UNT SYSTEM™
Strategic Infrastructure,
Planning & Construction

DATE: January 16, 2026
TO: Potential Respondents
FROM: Carrie Stoeckert—Construction Contract Expeditor III
SUBJECT: Questions #1
RFQ752-26-1016CS
UNT Central Utility Plant

Denton Campus Chill Water Loop

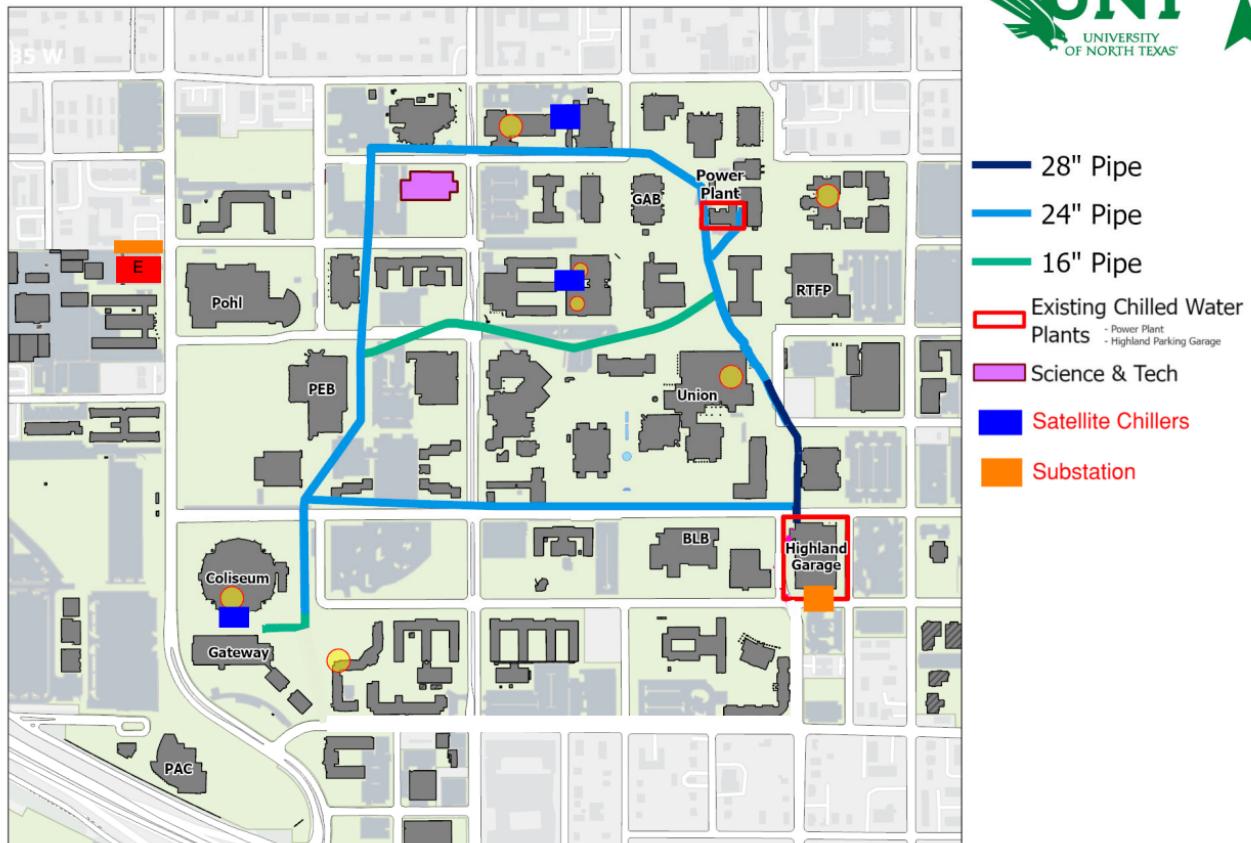
10. The RFP mentions a new plant to alleviate strain on two (2) existing CUPs. Is there a map showing the location of the other 2 CUPs and where the connection to the water lines will be?

23. Will a map be provided showing the approximate location of the connection to the existing chilled water loop?

34. Where is the chilled water loop that we are tying into located at?

46. As discussed in the pre-bid meeting onsite, please provide a tie-in point to the existing Chiller water lines on a map.

Answer: See Denton Campus Chilled Water Loop Map

Answer: See UNT Campus Chilled Water Loop Map

Answer: See UNT Denton Campus Chilled Water Loop Map

Answer: See UNT Denton Campus Chilled Water Map
